DEPARTMENT OF TRANSPORTATION

National Highway Traffic Safety Administration

New Car Assessment Program (NCAP)

ACTION: Final decision notice.

Figure 1

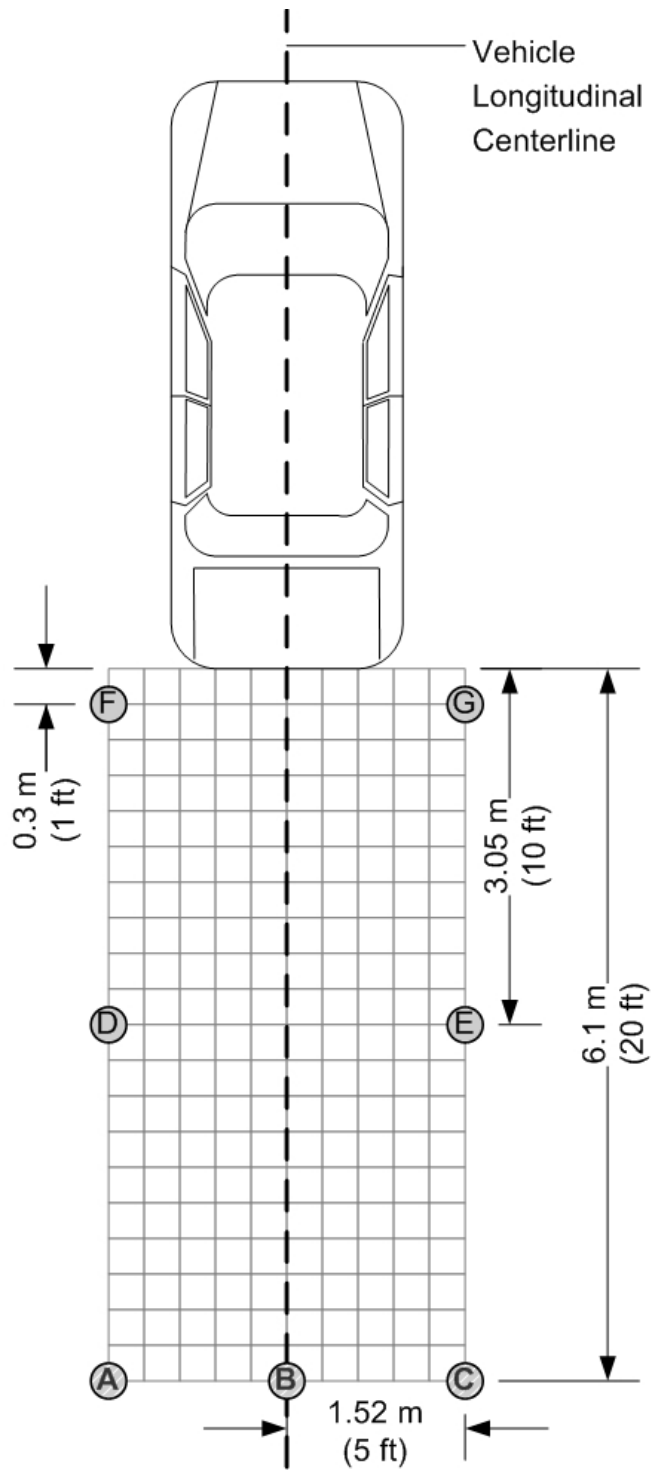
Certain manufacturers expressed two concerns with this test procedure to evaluate the field of view criterion. First, both the Alliance and Global Automakers assert that test objects F and G should be placed in a location that is proportional to the vehicle width (as opposed to 5 feet to the left and right of the vehicle centerline). They contend that vehicles using a 130 degree camera would not cover the required portions of test objects F and G (in their current locations). Second, the Alliance stated that certain vehicles with a low rear height (i.e., a vehicle that is not high off the ground) has less height flexibility for mounting a camera. Thus, the Alliance suggests that vehicles with an upper protected surface of the rearmost body structure of 750 mm or less be required to show only a minimum height of 0.4 meters (half the height) of test objects A through E (objects greater than 10 feet from the vehicle bumper).

We disagree with the manufacturers that this procedure for evaluating the field of view criterion does not accommodate vehicles with rearview video systems using a 130 degree camera or vehicles with a low rear height. When we originally developed this test procedure for the NPRM to amend FMVSS No. 111, we specifically designed this test procedure to be able to accommodate these types of vehicle designs. In response to the manufacturers' first concern, it seems clear that if we take into account three-dimensional nature of a camera's field of view, a 130 degree camera will cover the specified areas of all the test objects even if the vehicle has a low rear height. In tests conducted by the agency, the vast majority of vehicles equipped with rearview video systems were capable of meeting the field of view requirements as proposed in the NPRM.¹³ Thus, we are unaware of any camera that has a vertical angle limitation which would prevent it from easily being mounted at a pitch which covers the full height of test objects A through E.

In response to the manufacturers' second concern, we note that the portions of the F and G test objects that must be shown are measured by width only in order to accommodate vehicles of varying height and width. Thus, we disagree with the manufacturers that a 130-degree camera is unable to cover the width parameters for test objects F and G. We believe that the diagrams presented by the commenters regarding the inability of the 130-degree camera to cover test objects F and G fail to consider the three-dimensional properties of a camera's viewing angles. As Magna, a rearview video system manufacturer, stated in their comments to the NPRM to amend FMVSS No. 111, a 130-degree camera can readily cover the 5.9-inch (150-mm) width parameters of test objects F and G when mounting height and camera pitch is considered.¹⁴
